Docket Number:	15-AAER-06
Project Title:	Small Diameter Directional LED Lamps and General Purpose LED Lamps
TN #:	206894
Document Title:	Philips Lighting Comments on Title 20 - 45 Day language 10-15-16
Description:	N/A
Filer:	System
Organization:	Philips Lighting
Submitter Role:	Public
Submission Date:	12/8/2015 11:29:29 AM
Docketed Date:	12/7/2015

Comments on Title 20 - 45 Day Language - Small Diameter Directional Lamps, General Purpose LED Lamps, and Portable Luminaires

Dr. David Woodward
Standards and Regulations Manager Americas
Philips Lighting

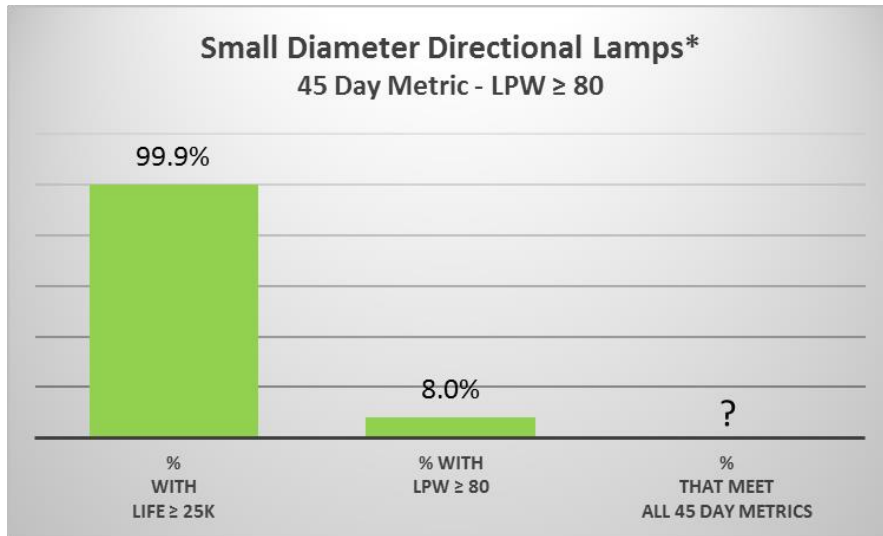
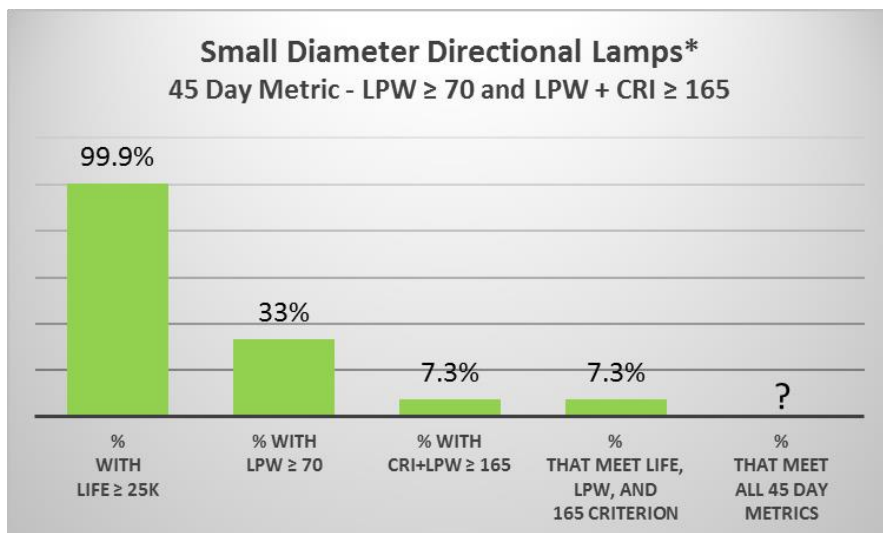
113 The situation with small diameter directional SSL lamps is similar. The proposed 45 day
114 language has two paths for product compliance: lamps with an efficacy of 80 LPW or greater,
115 or lamps with an efficacy of 70 LPW and a combined score of CRI + LPW \geq 165.
116

117 In either case, analysis of the lamps on the certified product list shows that 8% or less of the
118 741 existing lamps will meet the 45 day metrics. This is illustrated in the graphs that follow.
119 Thus, conservatively speaking, 92% of the currently available small diameter directional LED
120 lamps will not be available to California consumers. This is illustrated in the graphs below.
121

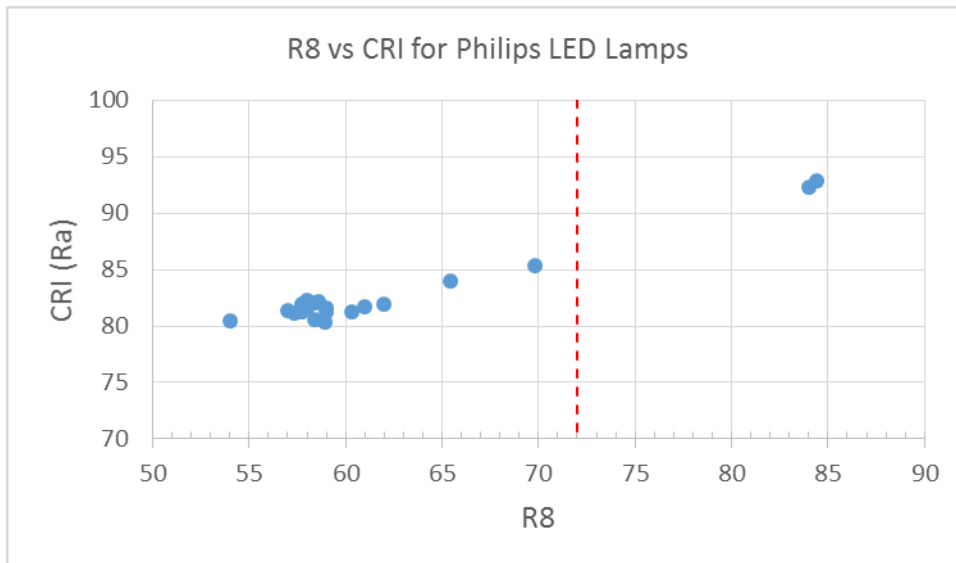
180 The above statement from the staff report is disingenuous. The required minimum color score
181 of 72 for the individual color indices of R1 to R8 cannot be achieved at the minimum required
182 CRI of 82, except possibly at color temperatures of 5000K or higher.

184 At CCTs of 2700-3000K, which the Commission proposes for lamps claiming incandescent
185 equivalency, lamps with R1 to R8 greater than or equal to 72 have CRIs greater than 85.
186 Appendix A has a table with data for 22 Philips LED models and in all cases where R1 through R8
187 is 72 or greater, the CRI is over 90. Below is a graph for the R8 of these same lamps vs CRI and
188 it shows that lamps with an R8 of 72 or greater will have a high CRI. This is the same conclusion
189 reached based on our analysis⁷ of R8 vs CRI from CLTC’s report⁸ on omnidirectional LED
190 replacement lamp performance testing.

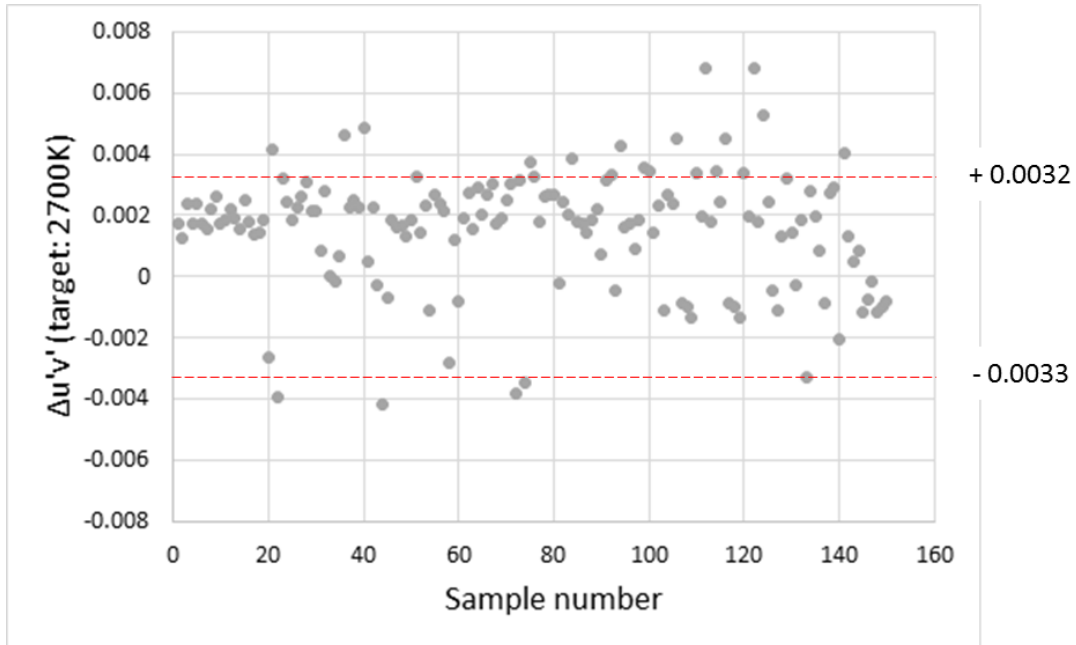
256
257 The following graph shows Duv data from 150 lamps sampled over 10 weeks of production for
258 the commercial version of the L Prize design. Superimposed on the data are the Duv limits from
259 the equation presented at the public hearing. These data show that not even this award
260 winning design will meet the Duv limits in the 45 day language.
